Environmental Impact Statement
Olympic Dam Expansion

Assessment Report

Minister for Mineral Resources Development and
Minister for Urban Development, Planning and the City of Adelaide

September 2011

DEIS Figure 5.52 Indicative configuration of the proposed land facility

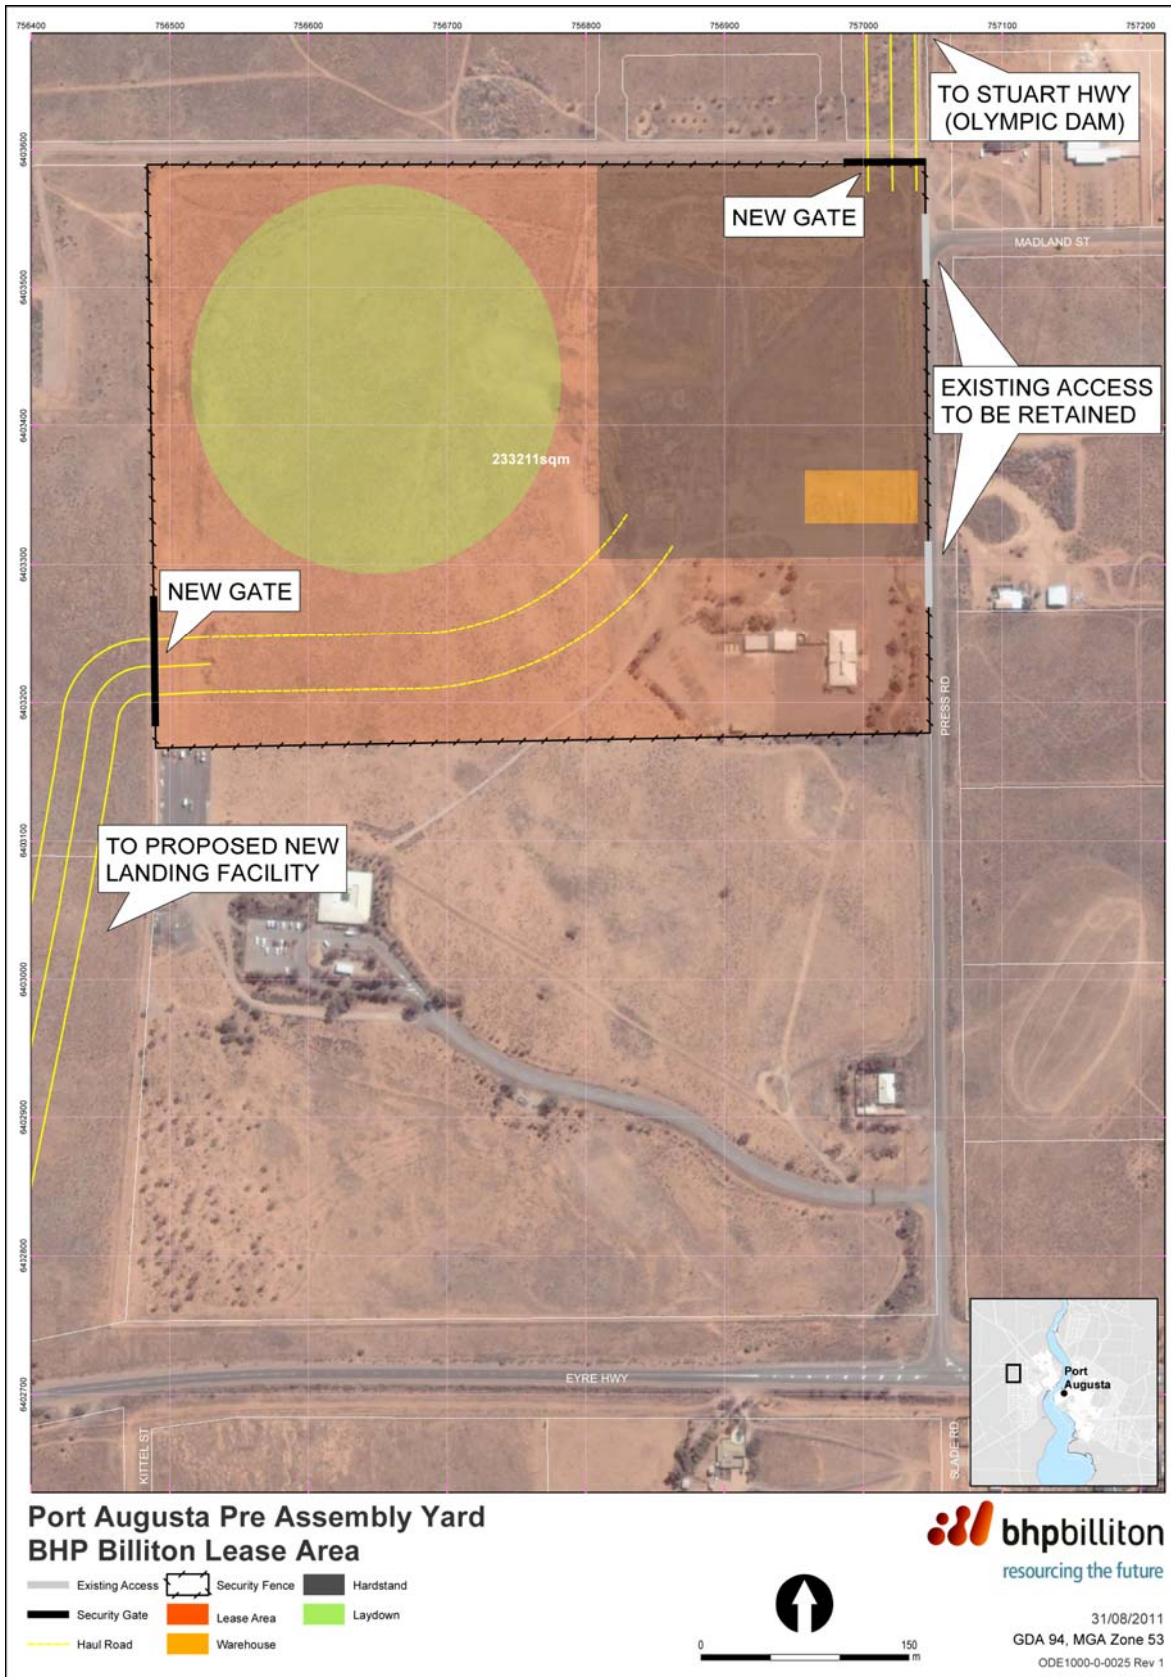
- Final designs for the landing facility must be constructed in accordance with DEIS Figures 5.52 and 5.53.
- The proponent must prepare and implement a detailed Landscaping Plan that includes a 3m vegetated buffer along the southern and northern boundaries, using locally indigenous species. The plan must indicate the mature height and density of species used to screen the facility along the perimeter of the facility. The Landscaping Plan must be lodged with Indenture Minister for approval prior to the operation of the landing facility.

SEIS Figure 22.3 Proposed alignment of access corridor, location of Port Augusta pre-assembly yard and rail crossings

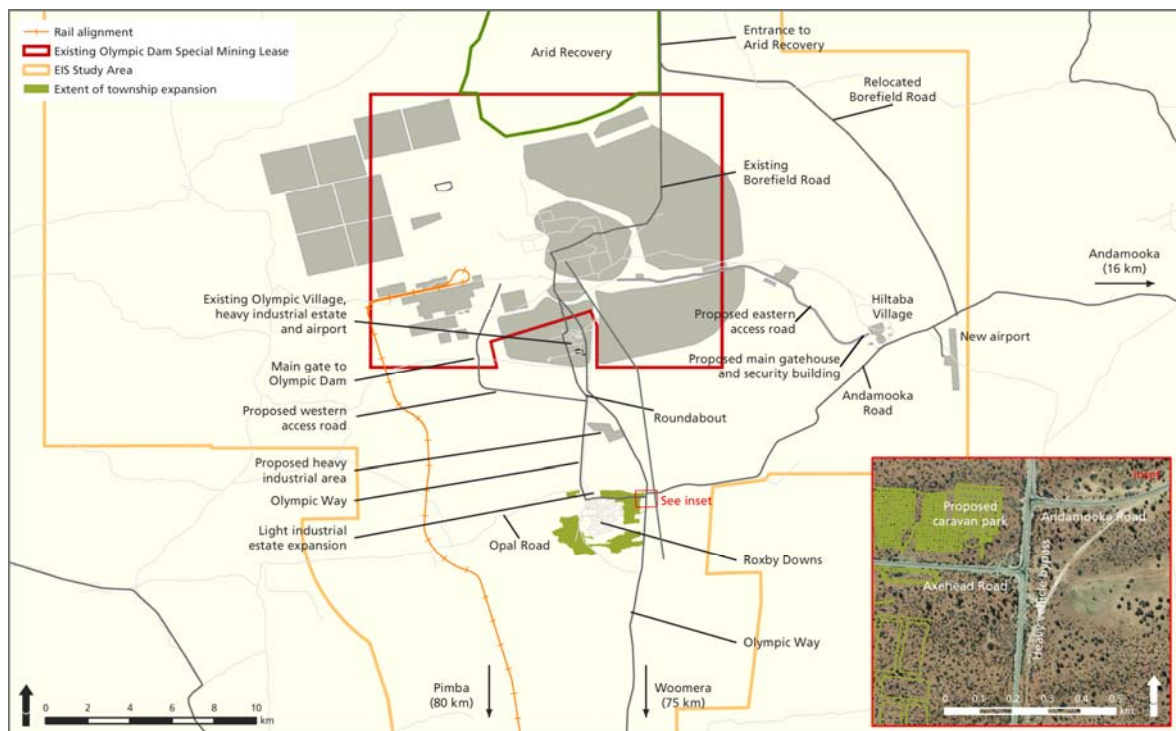
The amended alignment of the proposed access corridor presented in the SEIS (Figure 22.3) matched the requirements and preferred alignment of the SA Government and Port Augusta City Council that was outlined in correspondence dated 31 March 2010.

- The access road from the landing facility to the pre-assembly yard in Port Augusta must be constructed in accordance with the alignment shown on SEIS Figure 22.3.
- The proponent must consult with and seek approval from DTEI, for the private access corridor from the landing facility to the pre-assembly yard, with all costs being the responsibility of BHPB.
